## SERVICE INFORMATION No. SI 40-157

Lycoming Service Bulletin No. 612 Oil Level Gage Replacement

# MANDATORY SERVICE BULLETIN

SUBJECT: Oil Level Gage Replacement

Figure 1  
Oil Level Gage and Oil Level Gage Plug Ring

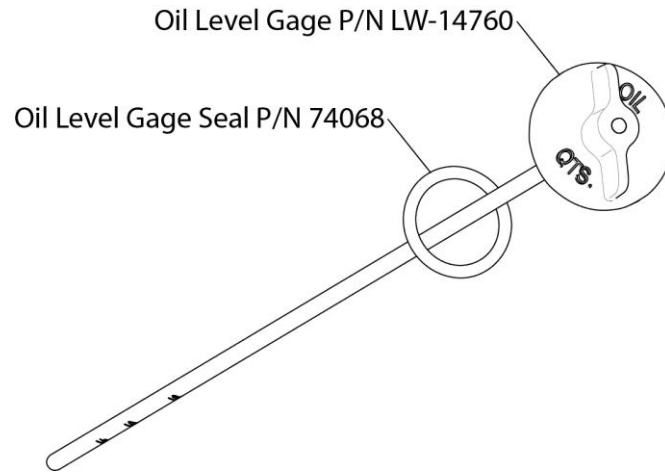
4. File a warranty claim through the same authorized Lycoming distributor for:
  - a. Reimbursement of the replacement oil level gage P/N LW-14760 and oil level gage seal P/N 74068.
  - b. Associated Freight.
5. Contact Lycoming Field Service at +1-570-327-7222 or 877-839-7878 if there are any questions.
6. Install oil level gage seal P/N 74068 on the new replacement oil level gage P/N LW-14760. Refer to Figure 1.

7. Install the new replacement oil level gage P/N LW-14760 with the oil level gage seal P/N 74068 on your engine.
8. Record replacement of oil level gage P/N LW-16783-18 with replacement oil level gage P/N LW-14760 in the engine logbook of affected engines.
